Re: Application for Comprehensive Permit – 440 and 526 Route 20, Shrewsbury

As you may recall, this firm represents neighbors and abutters to the proposed 250-unit residential development located at 440 and 526 Route 20, Shrewsbury (the “Project” and the “Project Site”), which is the subject of a pending application for a comprehensive permit under General Laws Chapter 40B, §§20-23 proposed by Smart Growth Design, LLC (the “Developer”).

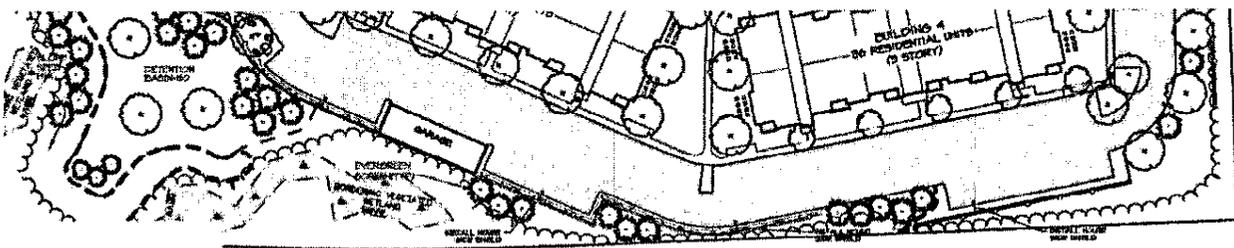
Relatedly, the Developer should provide a more robust landscaping plan with dense vegetated screening and fencing between the Project and the residential abutters. The "planting and lighting plan" sheet filed the Developer in November is lackluster, and offers only a handful of evergreen trees along the rear property line, a number of which are within the detention basin area, which the Developer has agreed to relocate in response to Graves' peer review comments. See, excerpt below:

The Developer has not shown where these detention basin trees would be relocated. Nor has the Developer identified what type of evergreen trees will be planted, or how tall the trees will be when planted (a number of different tree species is identified on the plan sheet, but the Legend is confusing as to how the species match up with the icons depicted on the plan). Given the significant unit density and building massing proposed adjacent to a single-family neighborhood, a robust landscape plan should be a top priority for this Project. We respectfully request the Board to require the Developer to submit a revised landscape plan with more natural screening, and fencing, along the rear property line. This submittal should be made as soon as possible to allow the Neighbors to comment on it before the public hearing closes at the end of the month of May.

ACTION ITEM #5: The Board should require the Developer to submit by next week a more detailed and robust landscape plan with dense vegetated screening along the rear property boundaries. The Board should then allow enough time for the public to review and provide comments and suggestions on the revised landscape plan.
